6-November-2020

RE: Response to Technical Evaluation Comments and Information Request
#3 for Underground Injection Control (UIC) Permit Application Class VI
Pre-Construction Permit Application No. R9UIC-CA6-FY20-1

Evaluation of the AoR Delineation Modeling Approach for CES-Mendota Class VI Permit Application

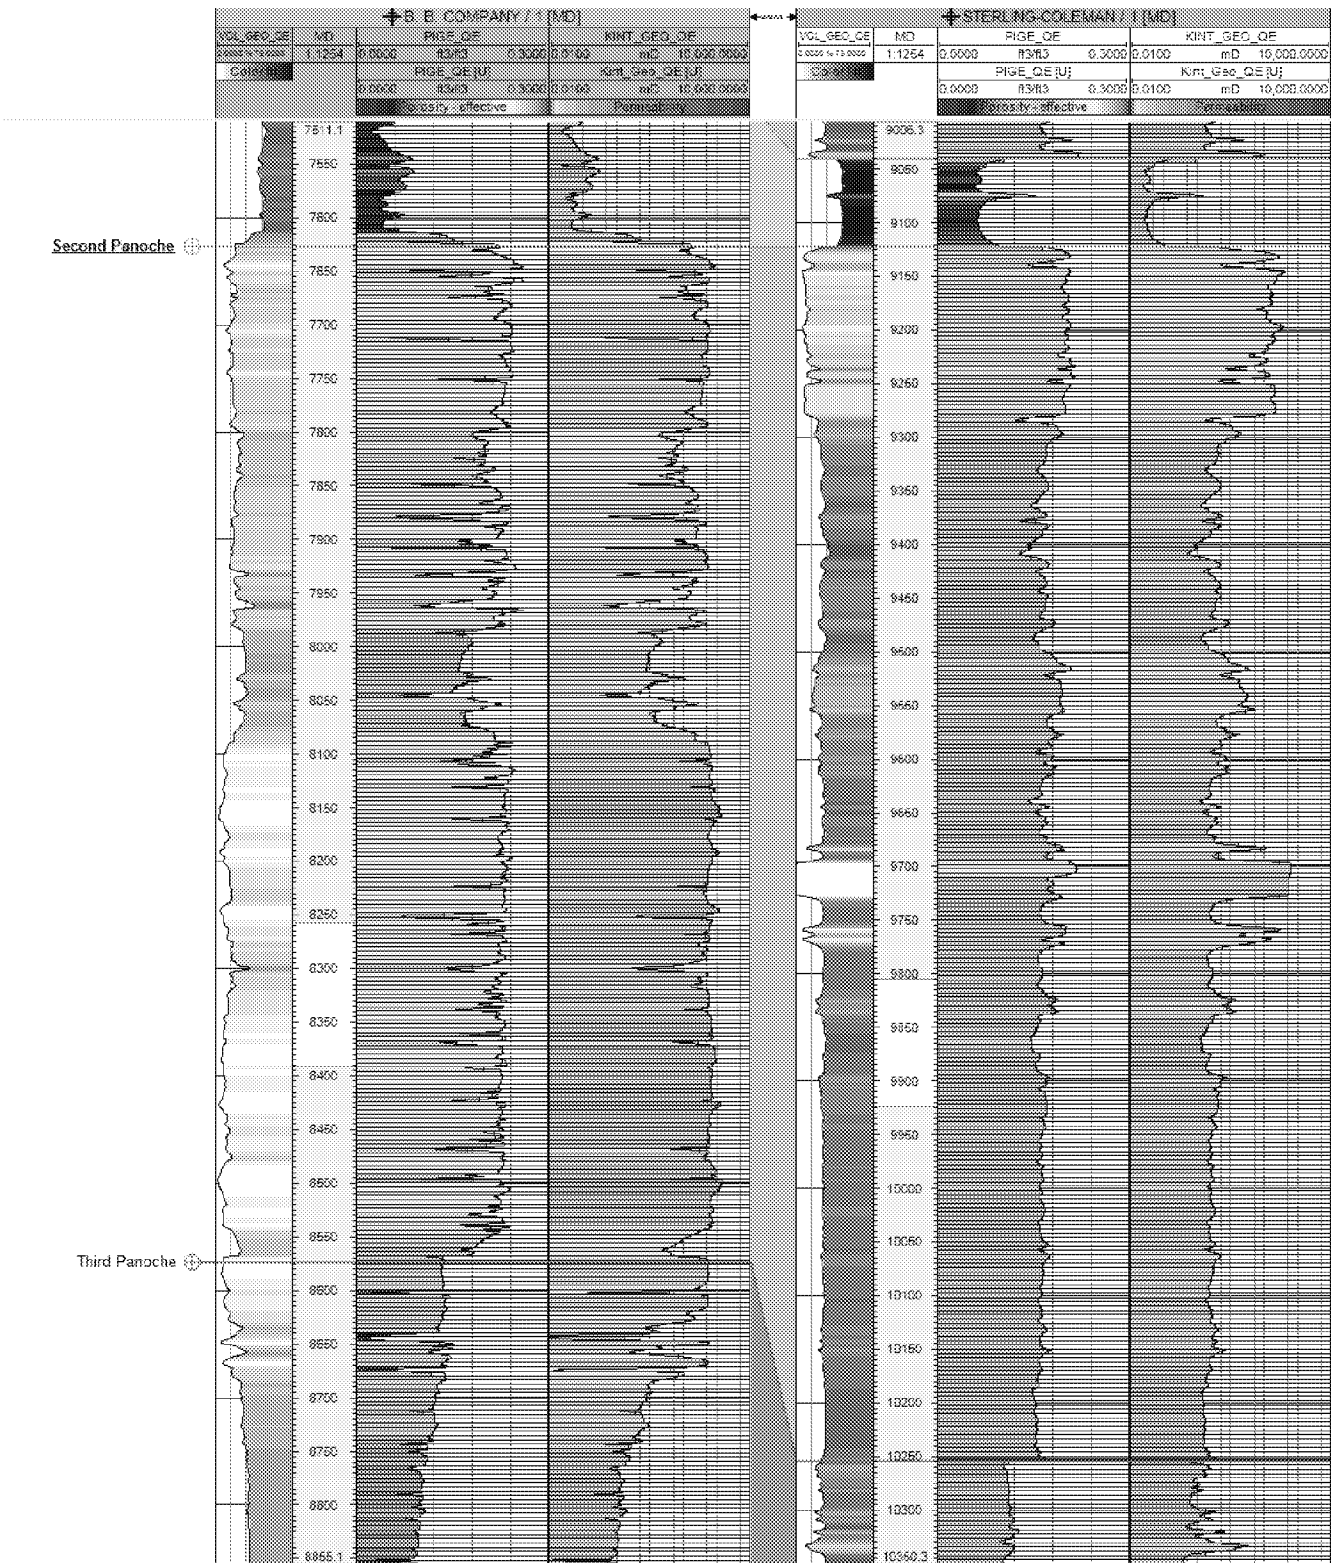
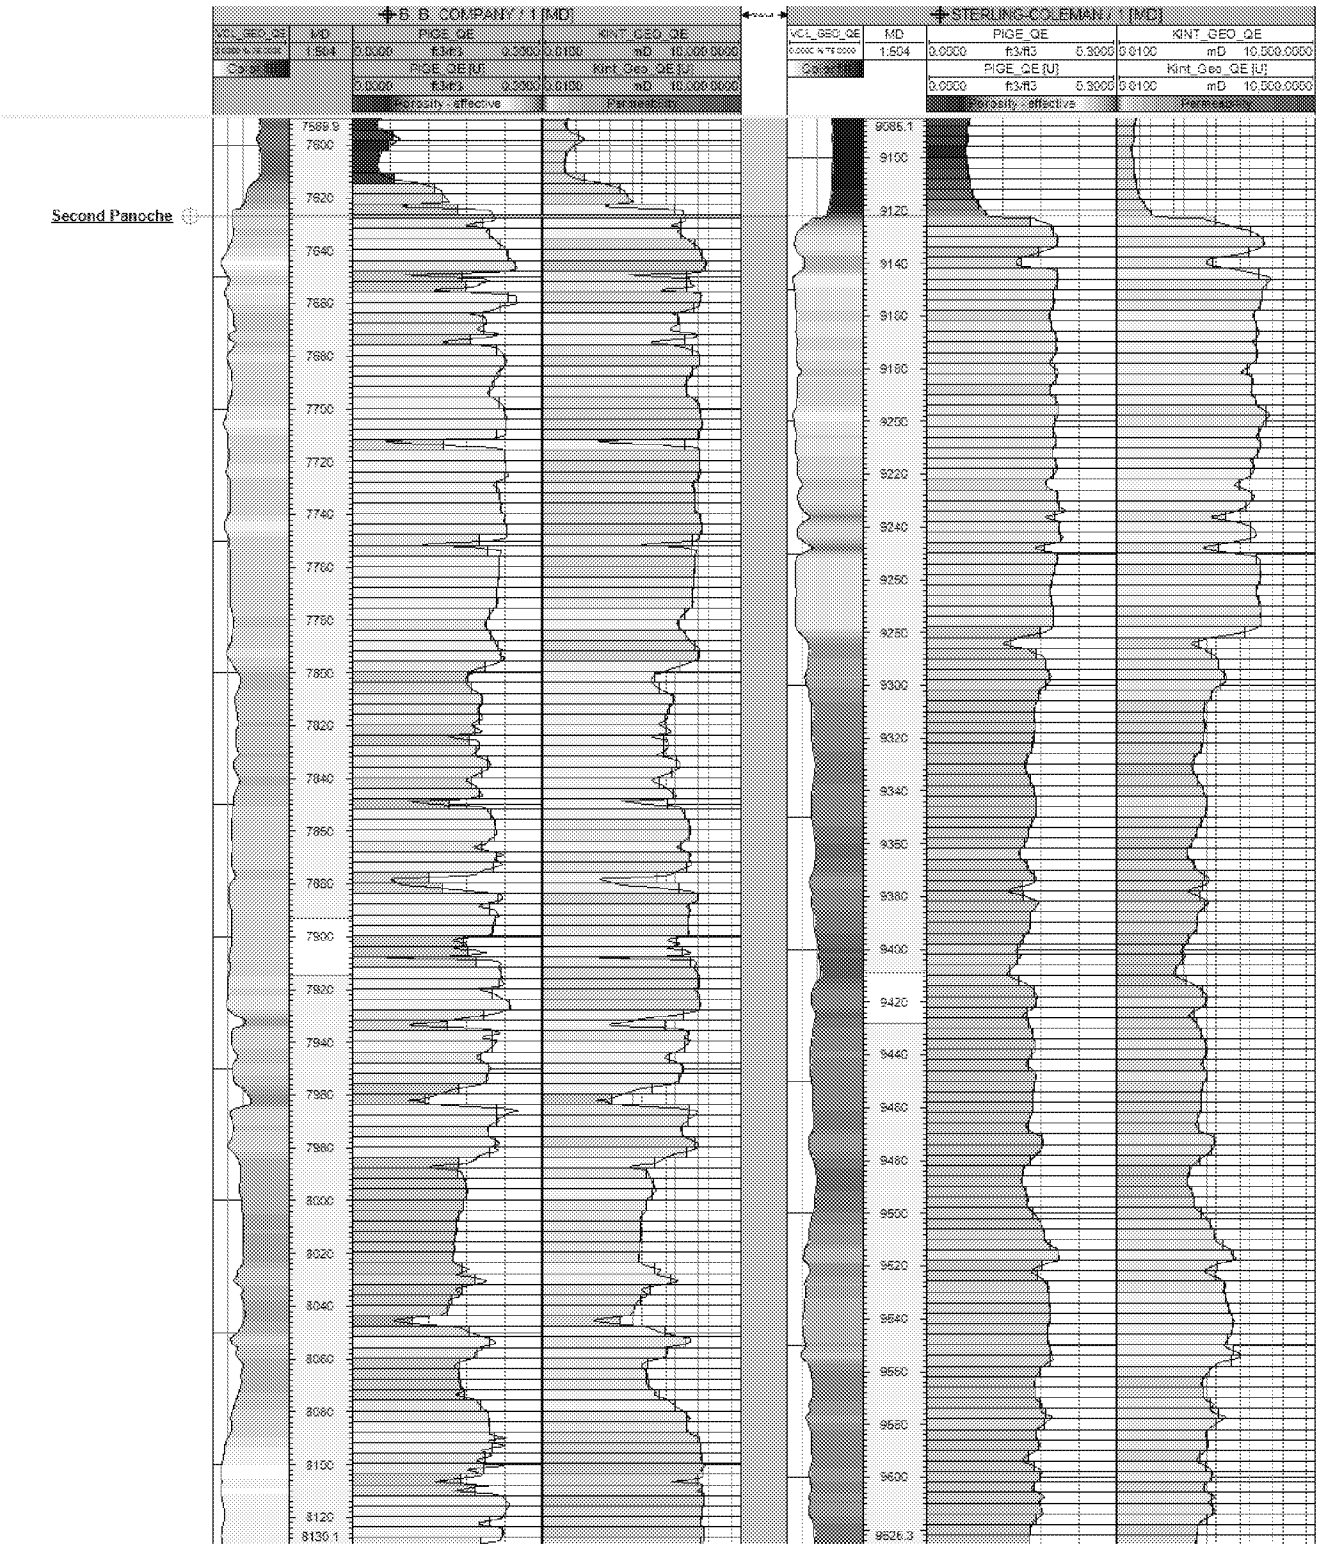
- What method was used to upscale the petrophysical properties along the wellbores of the 10 wells for which logging data were used? How was upscaling handled for the different formations? How was the success of this method evaluated?

- *Effective porosity and permeability were upscaled using arithmetic averaging methods. Although the geometric mean upscaling method can be used for permeability, in this case, the arithmetic method was most representative of the well logs. Please refer to Figure 1 and Figure 2 in Appendix A. Layer thicknesses are constant per modeled zone. Upscaling results were quality checked using histograms and crossplots comparing the raw and upscaled data. Histograms and crossplots show a reasonable match throughout the modeled zones.*

Figure 5: Porosity-permeability crossplots of well logs vs. facies type (sand and shale) (from Petrel 2019).

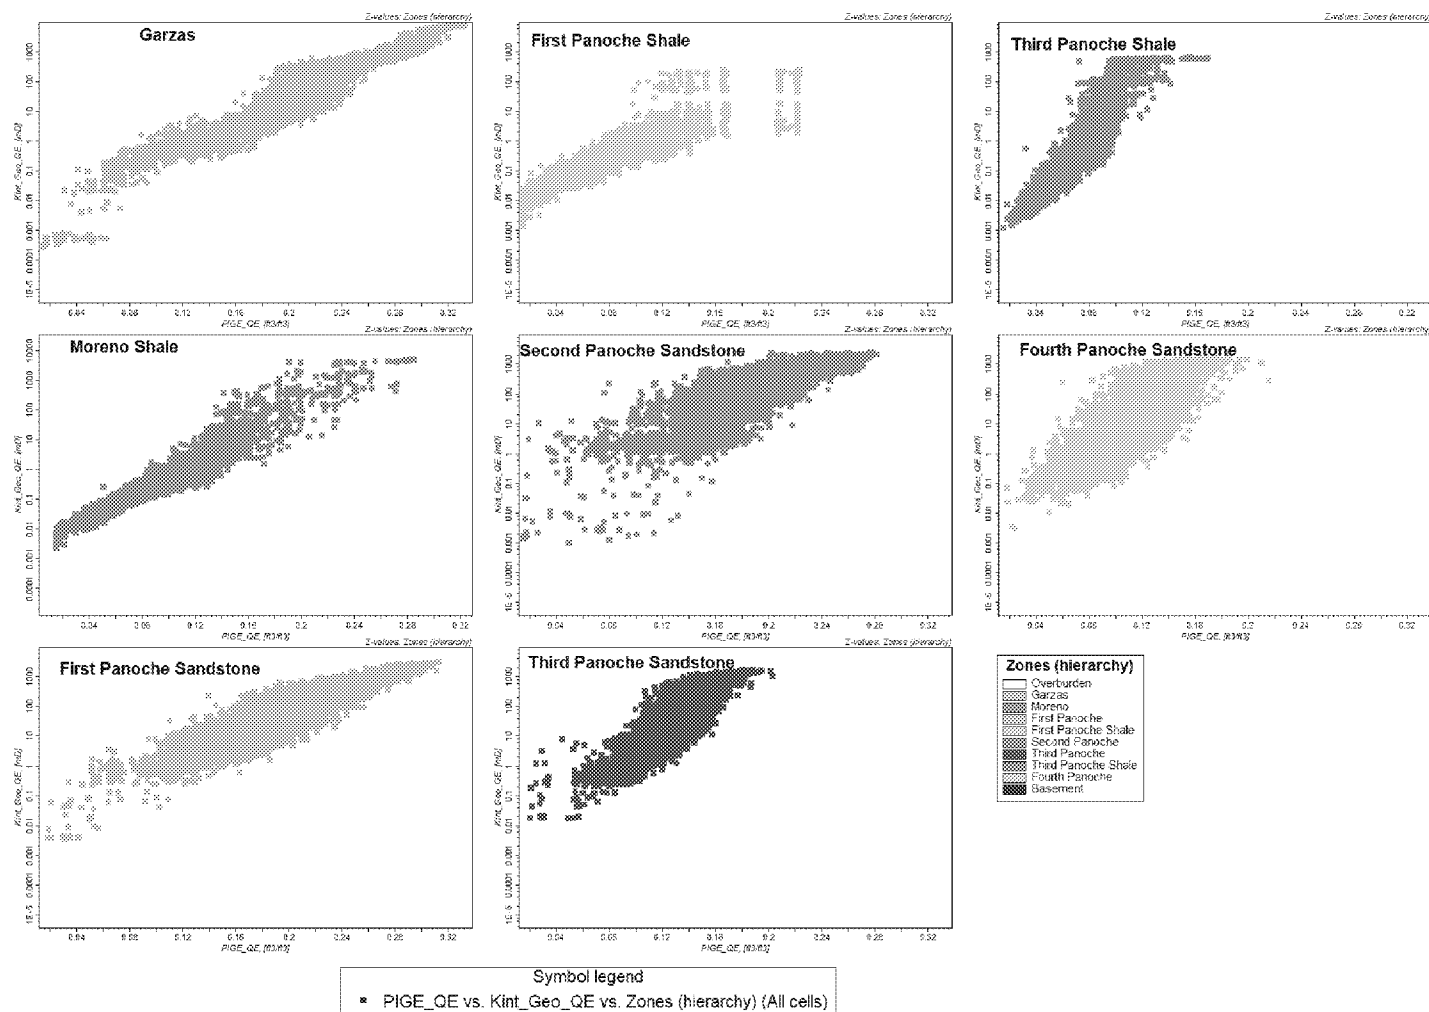
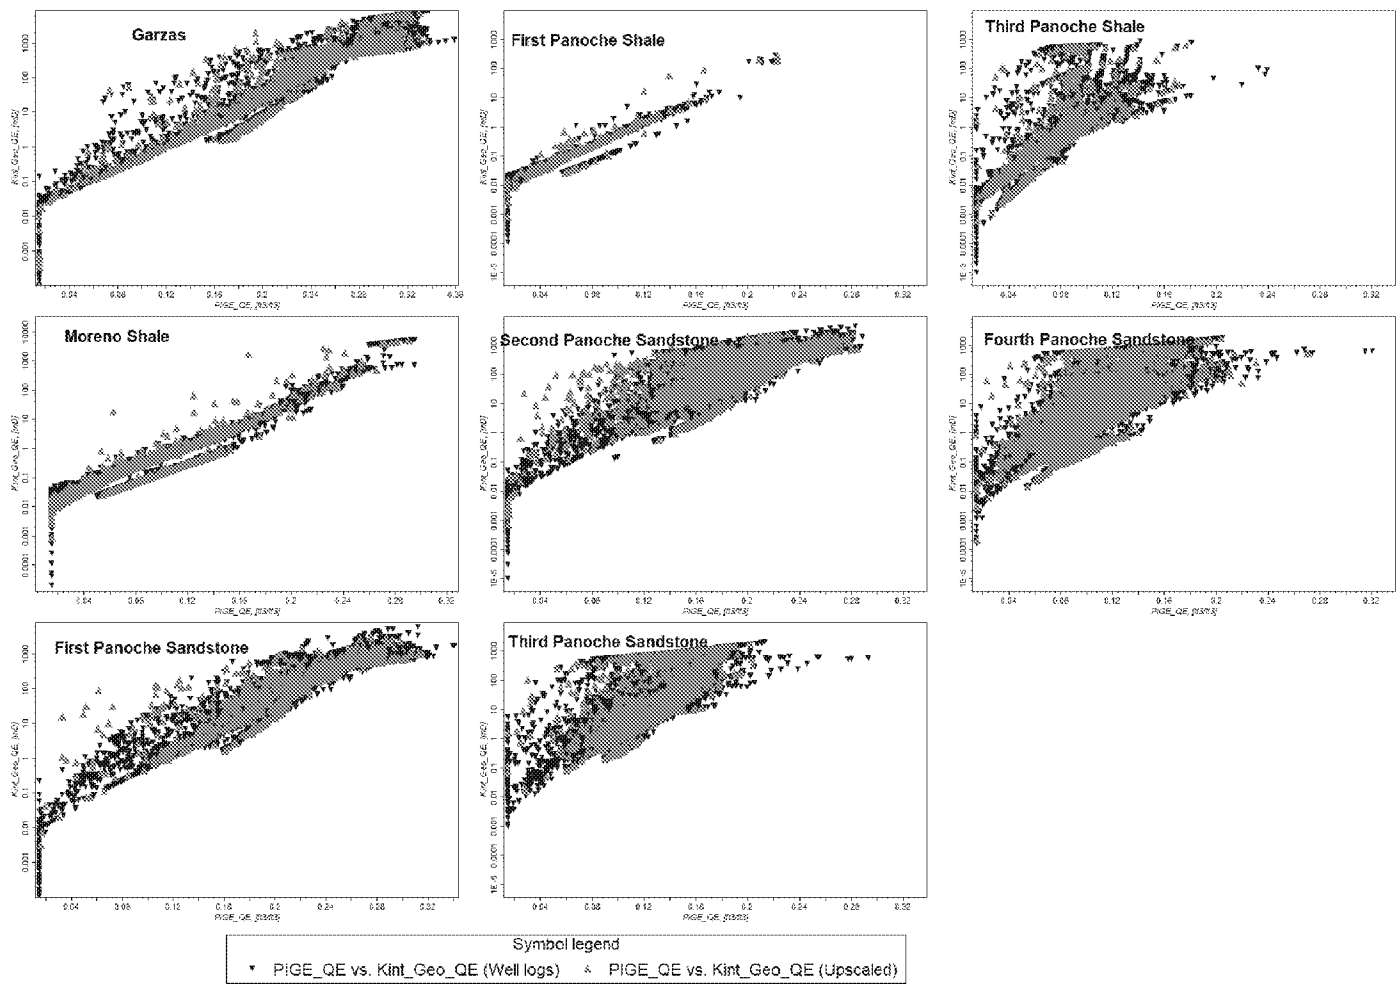
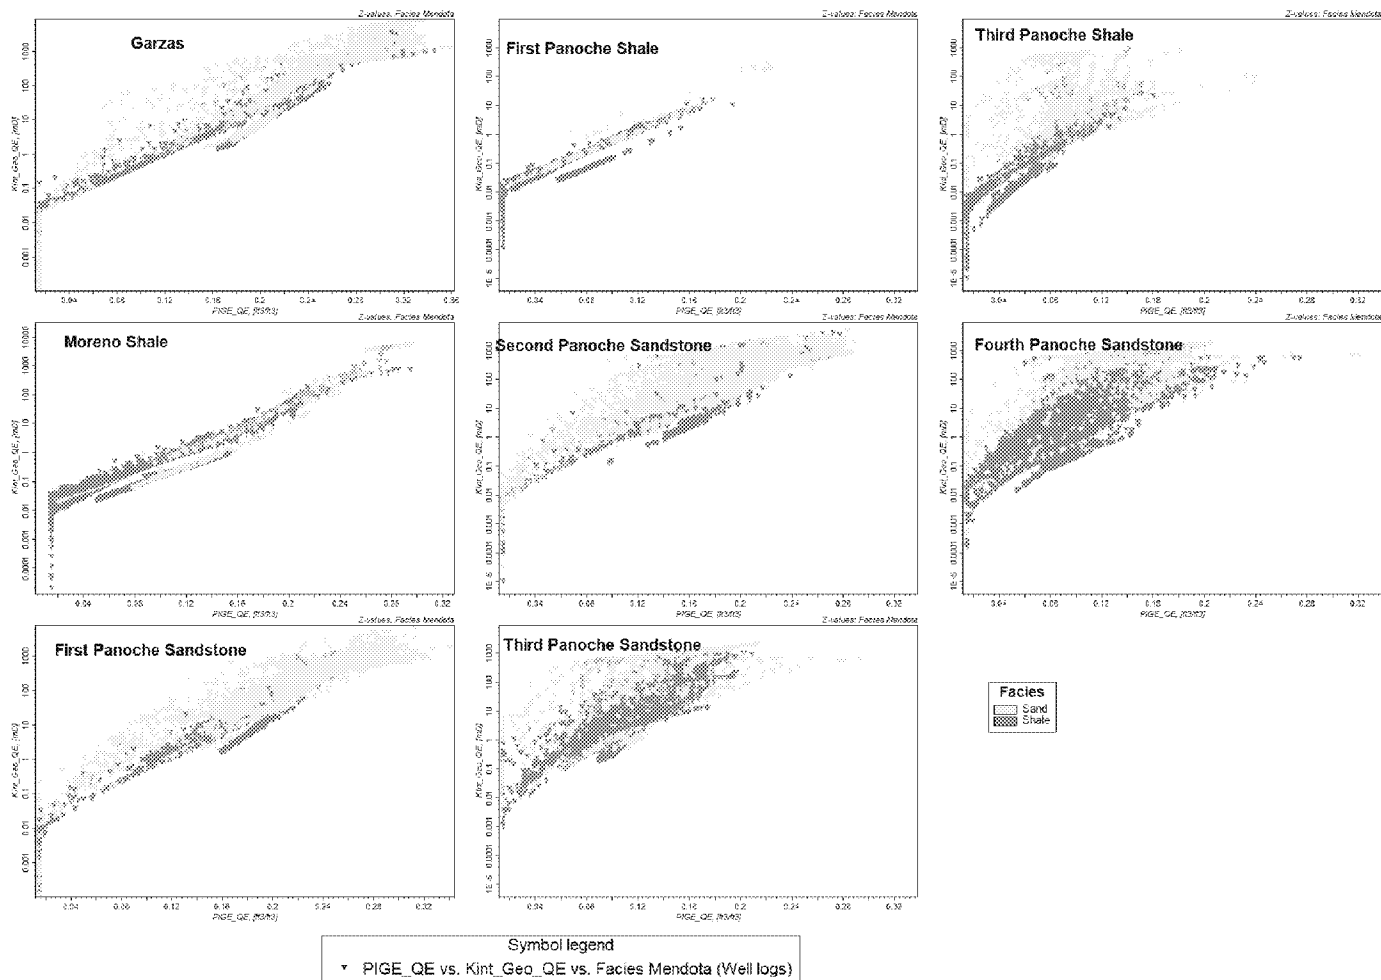
- In the plot of well log-derived data points, upscaled values, and full-field simulated cells, the

upscaled values dominate. It appears that the upscaled value symbols may have been layered over the other symbols. Please revise the figure to show the distributions of all three types of data points more clearly.

The graph in Figure 30 of the narrative showing porosity vs. permeability by formation is labeled as Z values and the legend title is “Zones.”

- Please clarify the meaning of the zones in the legend of Figure 30. Are they equivalent to the formations, as suggested by the legend?
 - *Zones are equivalent to formations. For clarity, Figure 30 has been updated and divided into Figure 3, Figure 4, and Figure 5 in Appendix A.*

• *For clarity, Figure 30 has been subdivided into three figures. Please refer to Figure 3, Figure 4, and Figure 5 in Appendix A.*

- Were the graphs in Figure 30 the basis for assigning phi and k in the layering in the model domain?
 - *For clarity, Figure 30 has been updated and divided into Figure 3, Figure 4, and Figure 5 in Appendix A. The graphs show the unique porosity/permeability relationships per zone. The corresponding variables were used in the layering model.*

- *Yes, the relative permeability and capillary pressure curves were the only properties assigned based upon the facies assignment.*
- Why was the information shown in Figure 30 of the narrative not used as the basis for assigning these curves?

In comparing Figure 1 in the Rock Type file with Figure 30 of the narrative, the facies in Figure 30 show a broad spread rather than the sharp dividing line in Figure 1. It appears that a number of shale data points in Figure 30 were assigned to the sandstone facies by the neural network training method in Figure 1. There also appears to be a significant difference in porosity between the Fourth Panoche and the Second Panoche Sands in Figure 30.

- *The facies model described in Figure 30 (updated with Figure 5) was a preliminary estimate to perform fault seal analysis. This facies log was not used as part of the petrophysical model interpolation. The rock classification methodology (neural network) was used to create the hydrofacies interpretation needed for dynamic modeling. Porosity and permeability of the geocellular model were upscaled to a tartan grid used for dynamic modeling. Please refer to Figure 6 in Appendix A.*

- Please discuss how these two methods of assigning facies were used to inform the geomodel and, consequently, the numerical model.
 - *The facies model described in Figure 30 (updated with Figure 5) was only constructed to characterize fault seal analysis; it was not used to inform the geomodel. The rock typing methodology with neural network was applied for the classification of hydrofacies (rock types) to assign relative permeability and capillary pressure functions in the dynamic modeling.*

Figure 6. Rock types along the E-W cross section (from Petrel 2019).

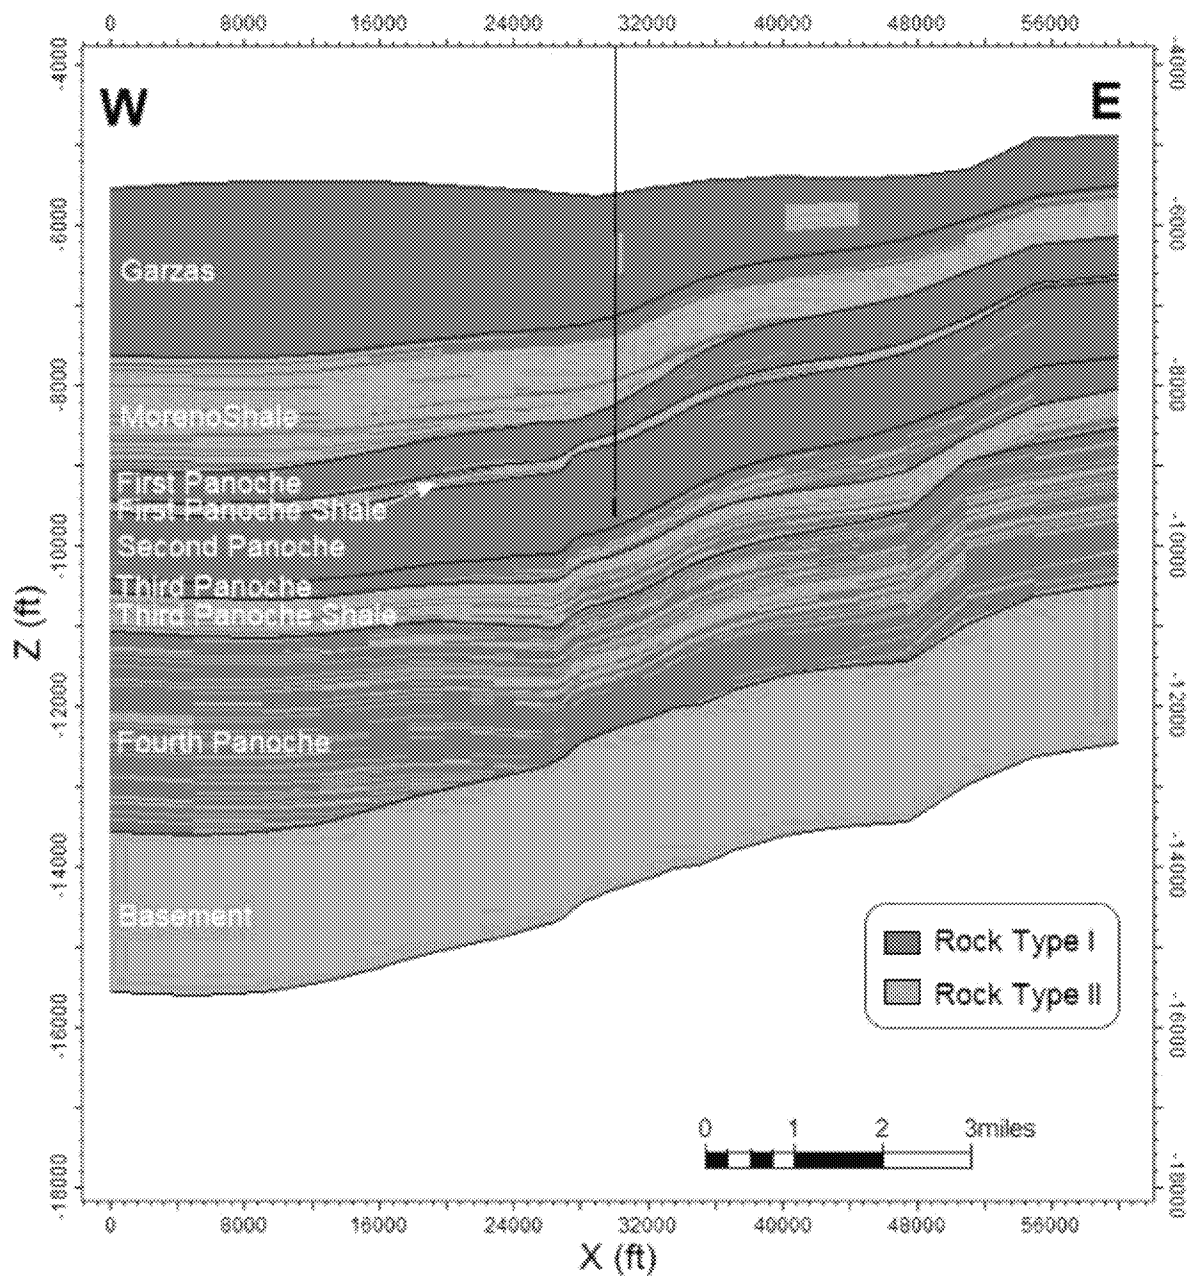
Figure 2 in the Rock Types file shows rock types along an E-W cross section. The cross section has two different shades of blue in addition to purple.

- Is there a difference between the two shades of blue in Figure 2 of the Rock Types file?
 - *No, the different blue shades are due to the presence of grid lines shown on the figure. Refer to Figure 6 in Appendix A for an updated version.*
- Please label the formations in Figure 2.
 - *Refer to Figure 6 for an updated version of Figure 2 in Appendix A which includes the formation names.*
